**Re: Plea to Council for Protection against DA Modification No: 10.2018.466.2 (61 Kingsley St, Byron Bay).**

**Re: DA Modification No: 10.2018.466.2 (61 Kingsley Street, Byron Bay):**

## **Submission to Council ( Re: DA Modification: 10.2018.466.2 )**

**Material Building Height Plane Breach**

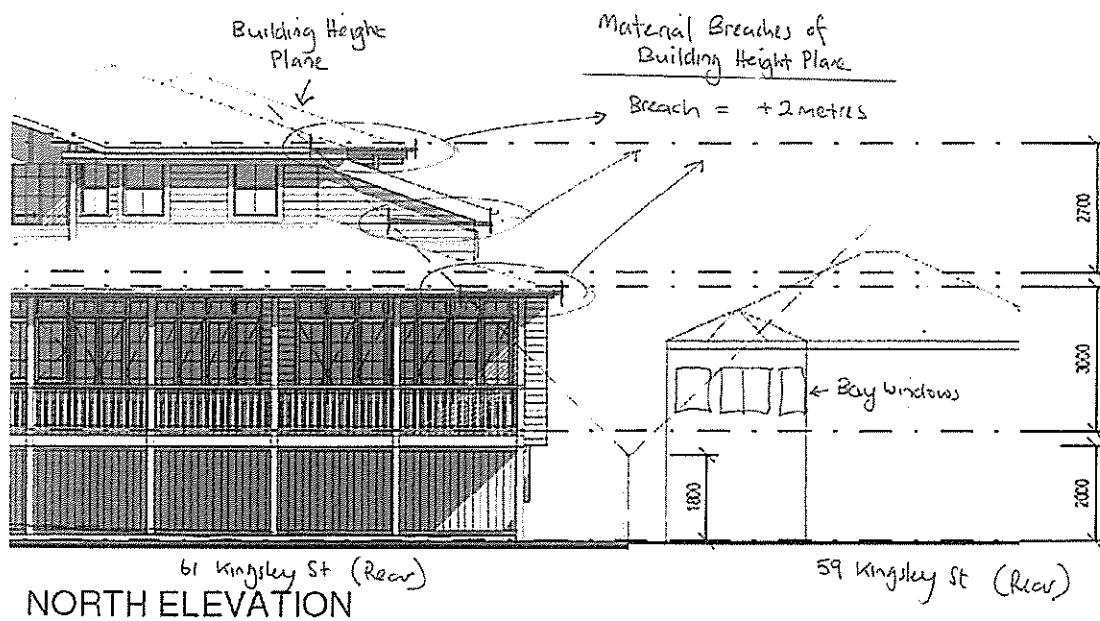
In fact, it is clear that the **material building height plane breaches** would have a **significant detrimental impact on our right to solar access and privacy** ... this is the fundamental basis to our ongoing objection to the DA, with the material building height plane breach clearly illustrated in the plan subsequently supplied to Council this week (as below).

This non-compliance inflicts resultant over-shadowing and a devastating impact on our access to solar amenity (and privacy). Additional vital information (impact on solar amenity and privacy) will be supplied by our Town Planner to Council in the coming days.

NORTH ELEVATION

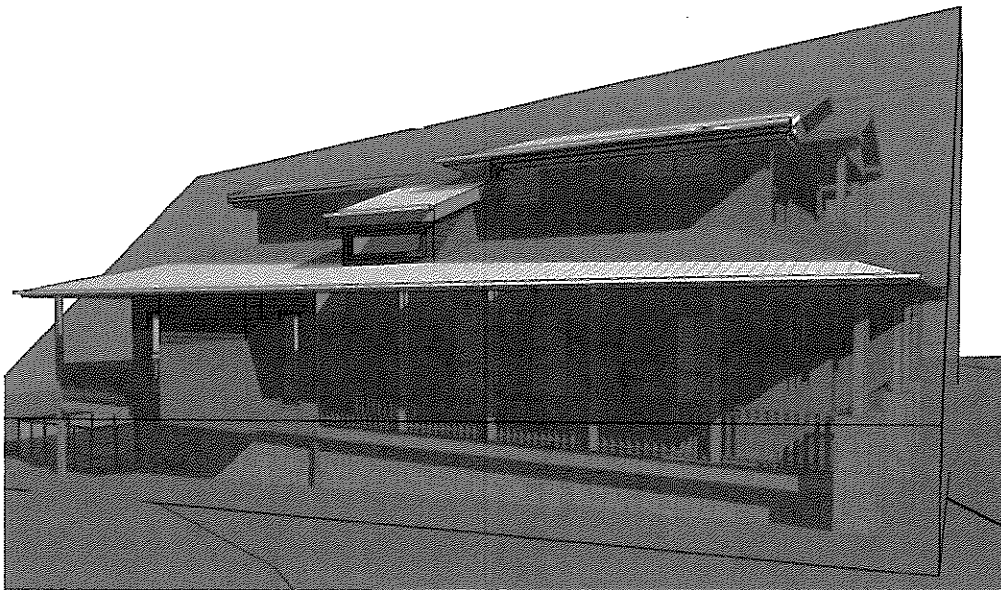
**Horizontal Height Plane Breaches** - The amended plan does nothing to address our primary concern, being the significant horizontal height plane breaches on the West Elevation (of 61 Kingsley) and significantly overshadowing our property on our East Elevation (refer image below) and entirely eliminating our access to winter sun.

The amended plans are misleading and have included height plane profiles from Kingsley Street, but have (conveniently) omitted to include a diagram showing the continued breach of the horizontal height plane on the West Elevation (notably at the rear). I am not sure of the exact dissection, but it appears to remain material (2-3 metres) and virtually unchanged, and directly impacts significant overshadowing (eliminating our winter sun entirely on our eastern elevation - refer shadow diagrams below) and also inflicting devastating impacts on our privacy, as highlighted by my approximate interpretation of the height plane breach (refer image below):

shadow diagram - june 21st, 12.00pm.

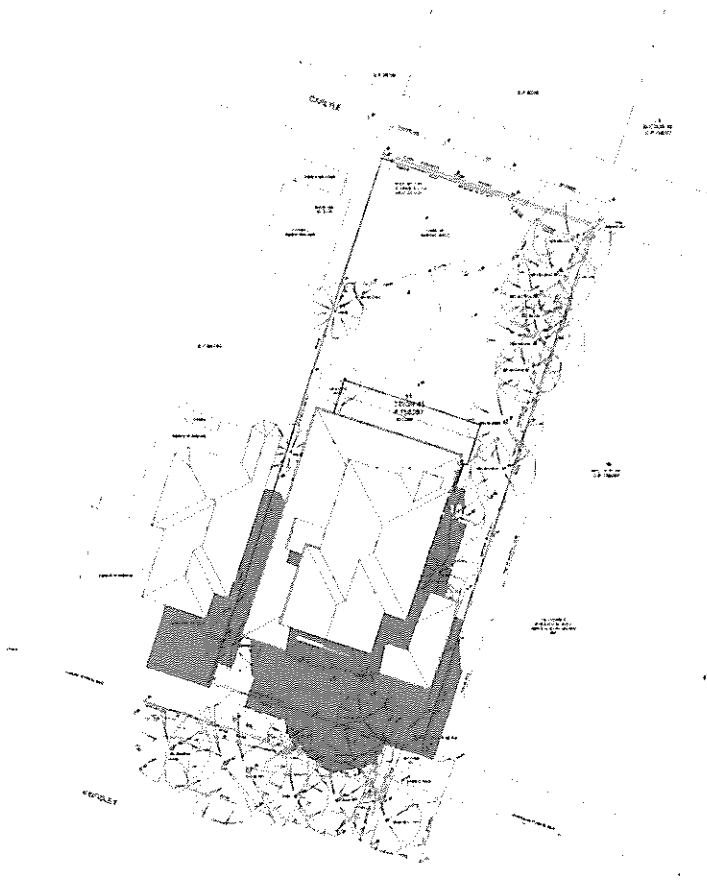
**Shadow Diagrams** - Further, the amended plans show shadow diagrams completely blocking out our access to winter sun (all day) on our East Elevation, and into our key private living spaces, however once again there are no shadow diagrams to show the current (pre-construction) shadowing.

In fact, we currently have full access to winter sun on the East Elevation, from as early as 6.30am and into the early afternoon, and this would be completely eliminated all day under the proposed plan, and as confirmed by the shadow diagrams contained in the amended plan (as per image below).

Extract of Latest Plan – WD 4.0 (Oct-19):

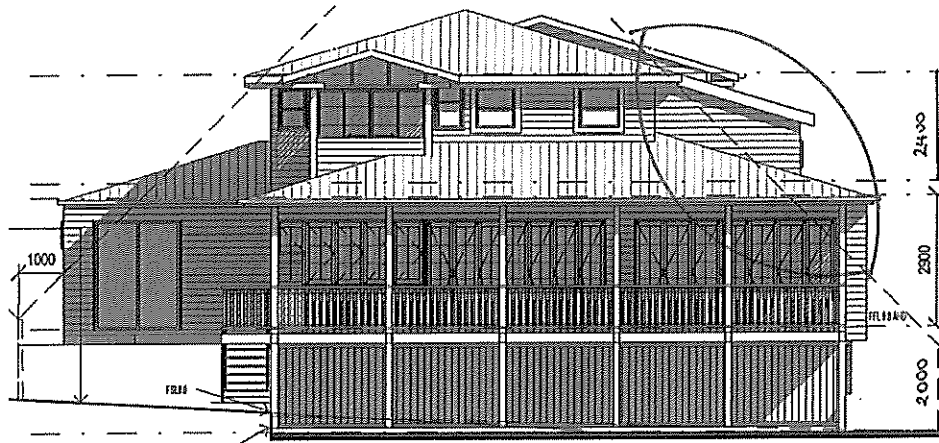
The proposed dwelling is a very large building, comprising three levels above ground (no excavation). The size of the dwelling is an issue for us given the impact of the breach of the building height plane on the western (side) elevation facing our home (refer drawing overleaf).

*Material Breaches of the Building Height Plane on the western side elevation (of +2-metres)  
(facing and overshadowing our home)*

Extract of Previous Plan: Building Height Plane Envelope (refer BHP breach on level one):

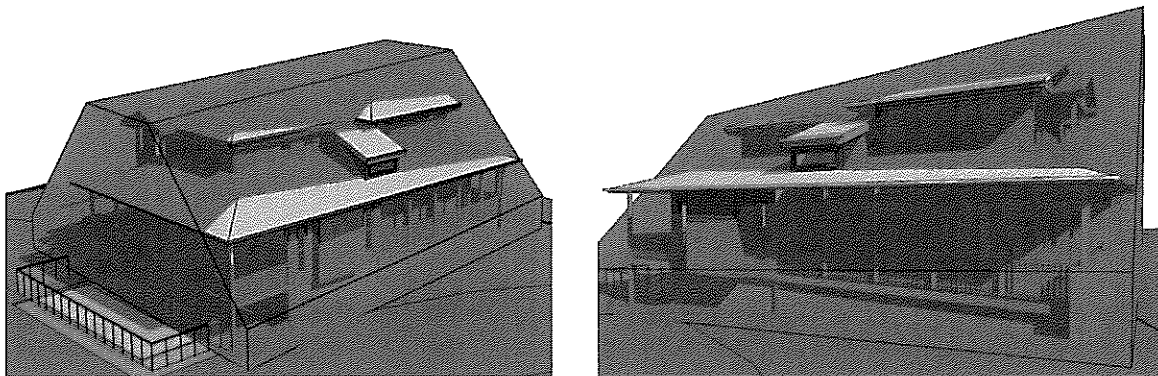
Nonetheless, below is diagram from the previous DA Plan (Feb-19), illustrating the extent of the building height plane breach. Most notable is the breach on the middle level (which is essentially unchanged under the Latest DA).

*Material Breaches of the Building Height Plain (of +2-metres)  
(on the western side elevation facing & overshadowing our home)*

Extract of Latest Plan (Oct-19): Highlighting Building Height Plane Breach (& overshadowing):

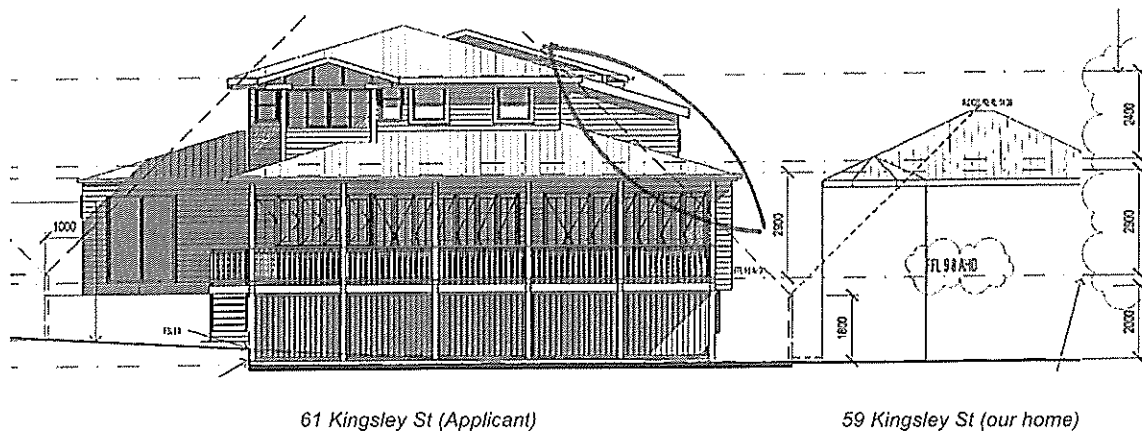
*Image of the Applicant's proposed dwelling (breaches of the building height plane highlighted in grey)*

Importantly, as explained earlier, our concern has never been the vertical height of the narrow apex of the roof (as long as it is sub-9.0-metres and compliant), our Strong Rejection has always been based on the extent of the building height plan breach at all levels on the western (side) elevation over-shadowing our home. This breach and over-shadowing primarily occurs on the middle level of the proposed dwelling (as highlighted by the diagrams above).

Extract of Latest DA Plan – WD4.1 (Oct-19):

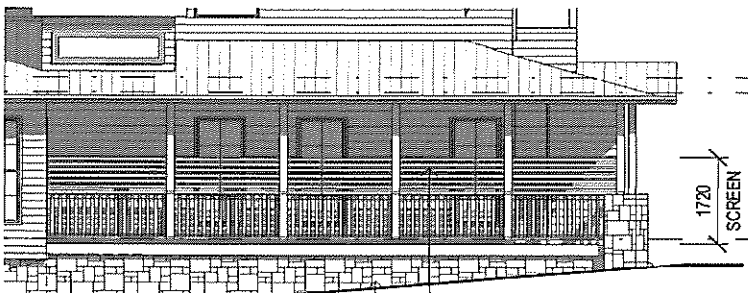
The Latest DA however, is seeking non-compliance by reducing the height of the privacy screen to 1.72-metres (which makes it ineffective as a privacy protection measure).

We **Strongly REJECT** the privacy screen being reduced from the approved 1.82-metres (to 1.72-metres).

#### **37. Hedge Planting**

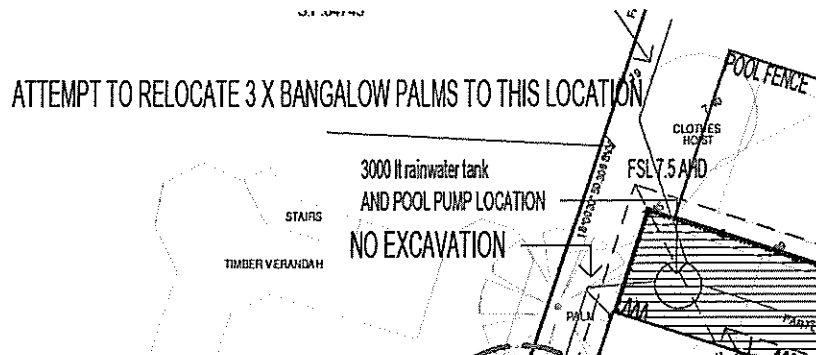
A minimum of 5 x native hedge plants are to be located along the neighbouring fence with No. 59 Kingsley Street where the pool and verandah are located. These must be able to reach a mature maximum height of 3 m.

This condition is explicitly designed to provide some privacy protection from the large (12.6 x 3.5-metre) outdoor deck (elevated at 2.0 metres above ground level) and extending across the entire expanse of the rear of the proposed dwelling.

The mature height limit of 3-metres is clearly designed to provide privacy, but also not impact solar access to the morning easterly sun.

**ATTACHMENT A****Sun Studies and Privacy Assessment from No. 1/59 Kingsley Street**

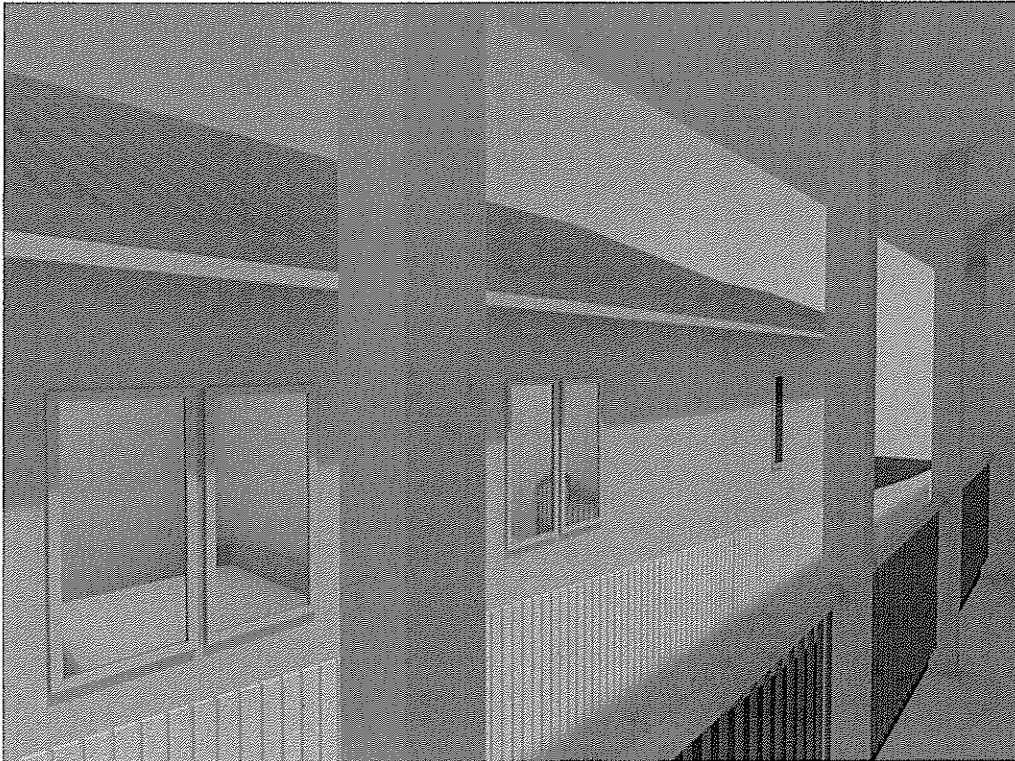
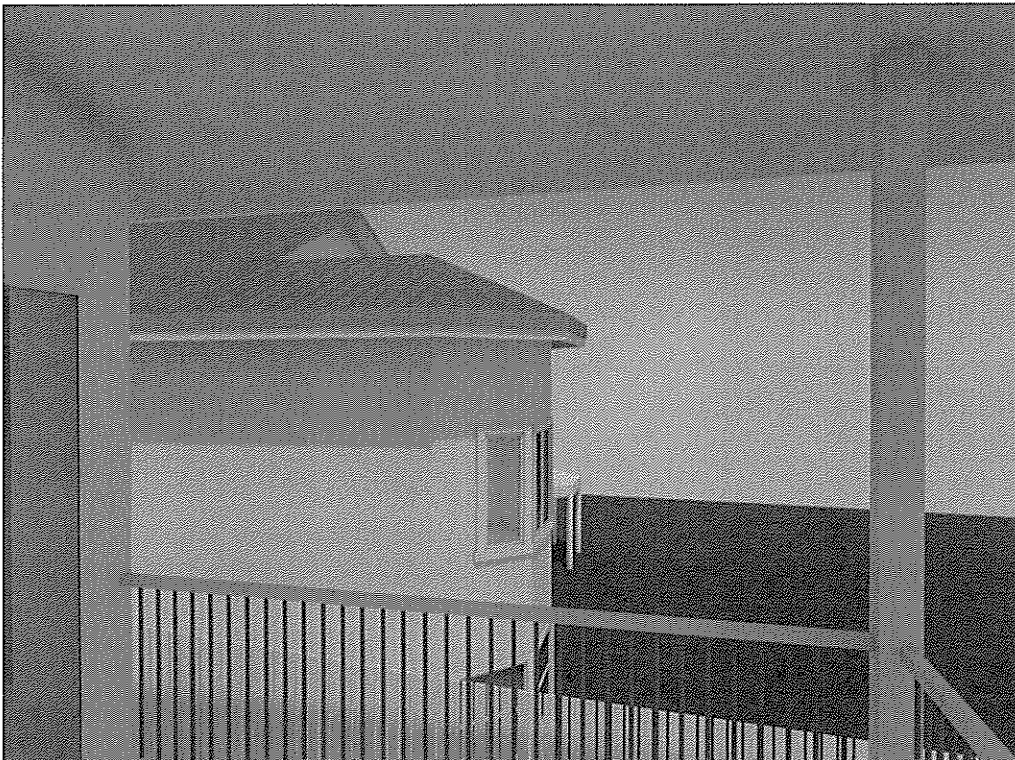
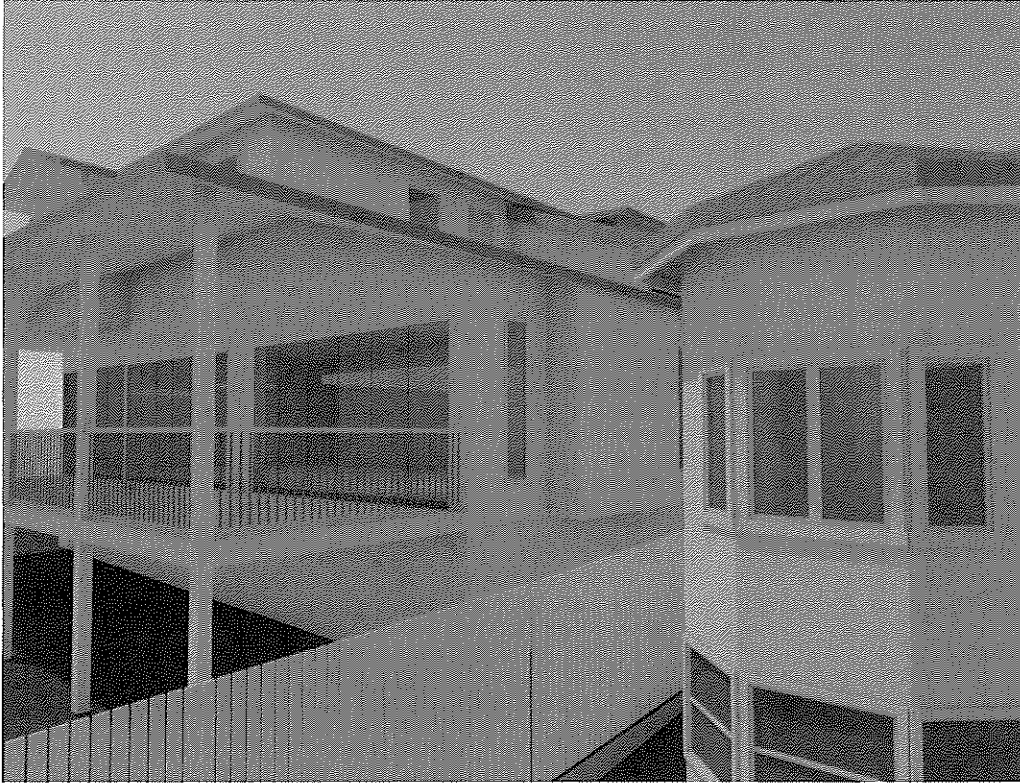
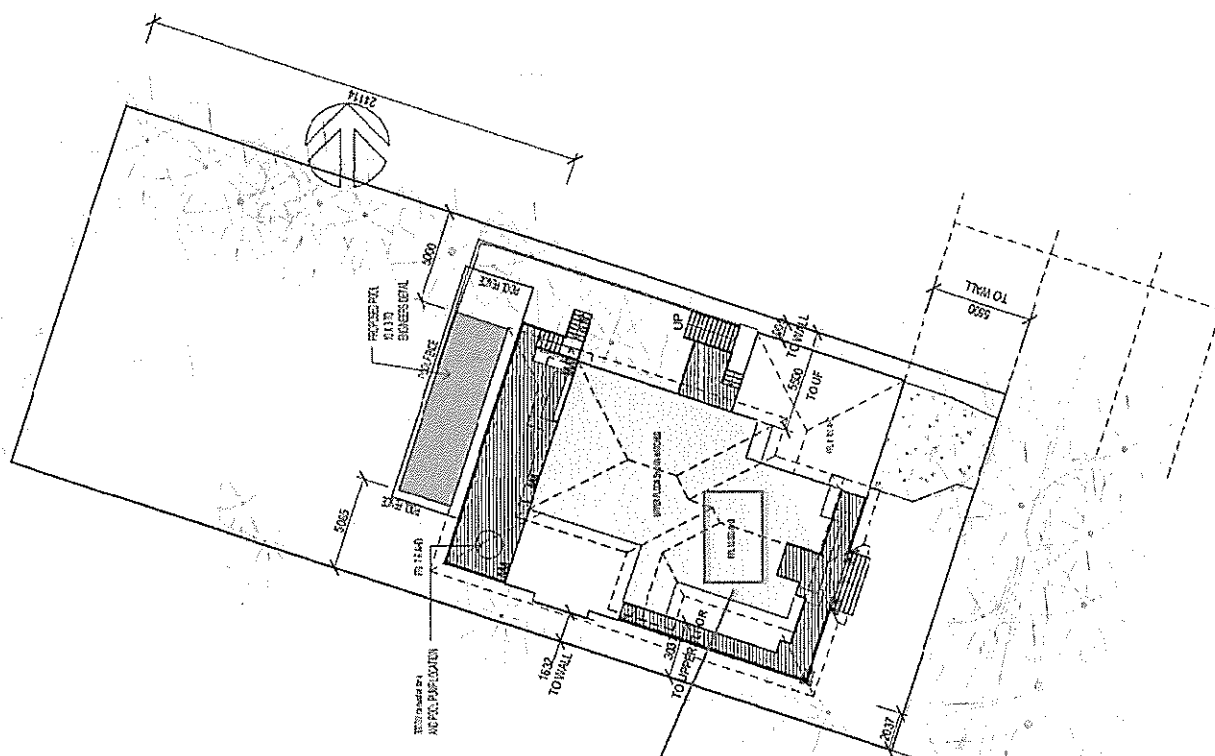
Firstly, it must be stated that it is disappointing to say the least, that the applicant has not supplied material to demonstrate compliance with the Performance Measures provided in D1.2.1 in relation to the Building Height Plane. As indicated in the sun study diagrams prepared for our client, the proposal results in overshadowing of living areas at 9am on 21 December and 21 June. Further, the privacy analysis provided clearly demonstrates the proposal will directly overlook living areas and bathrooms of 1/59 Kingsley Street. The impacts are not considered minor and it is submitted that the proposed scheme should be modified to comply with the Building Height Plane Prescriptive Measures given its failure to meet the Performance Criteria.

NORTH ELEVATION

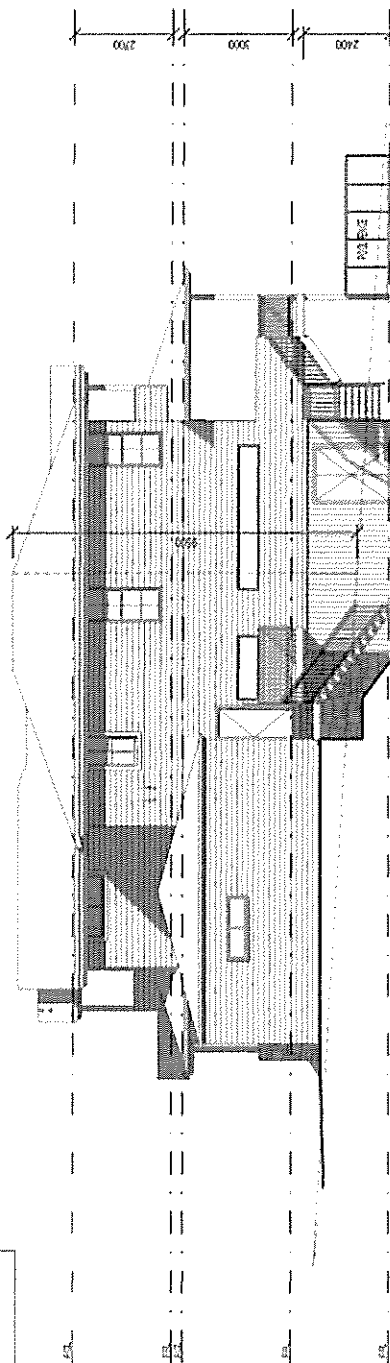
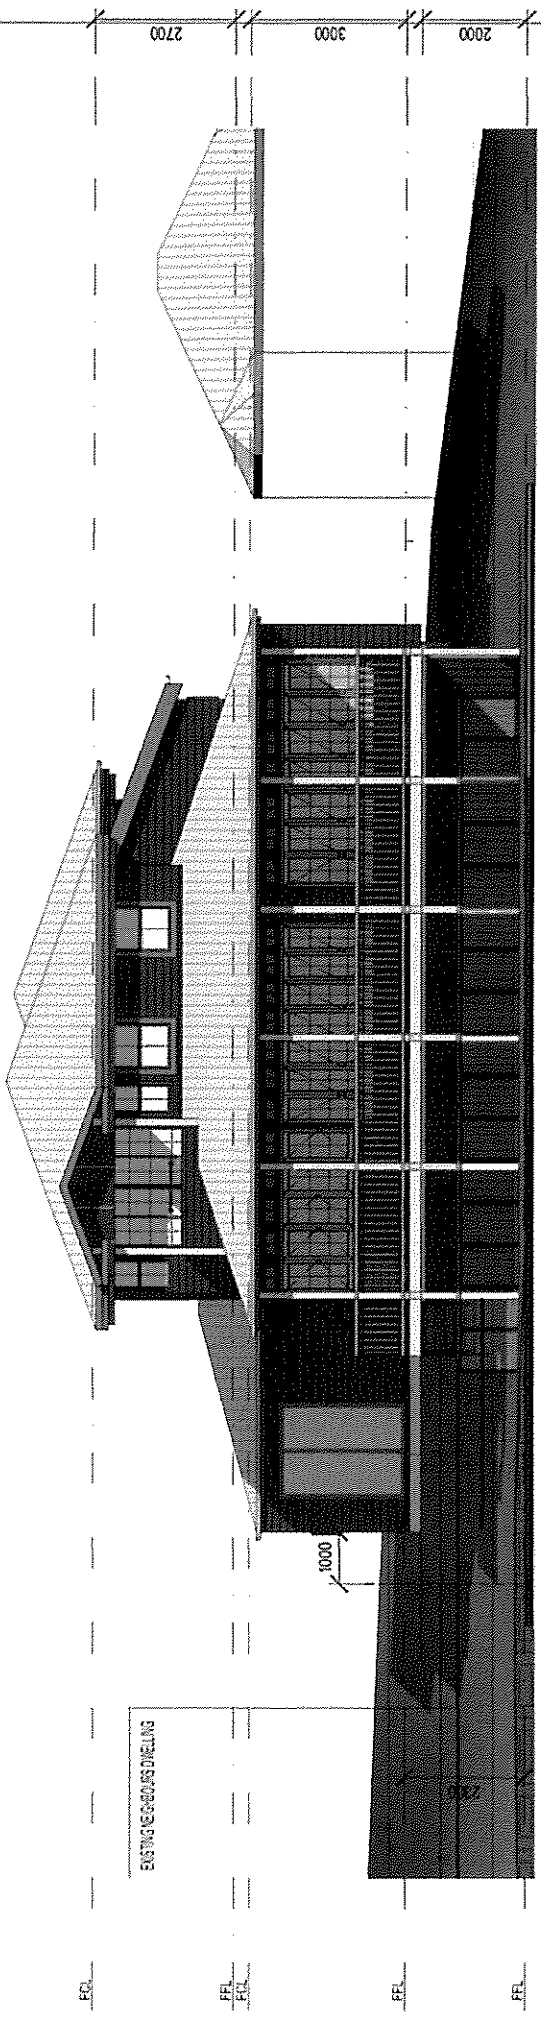
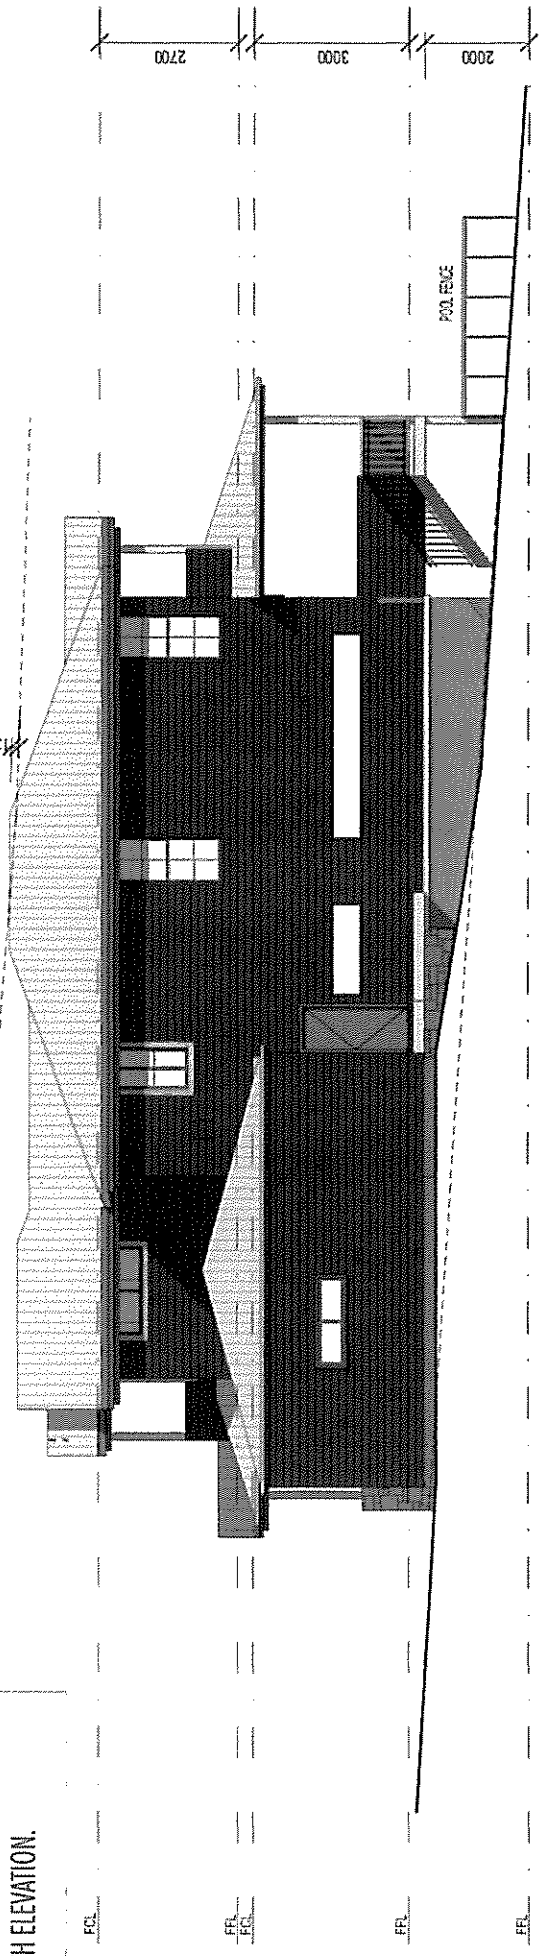
**ISSUE E:  
MISSING BUILDING HEIGHT PLANE  
IN NORTH ELEVATION.**

ISSUE E:  
MISSING BUILDING HEIGHT PLANE  
IN NORTH ELEVATION.
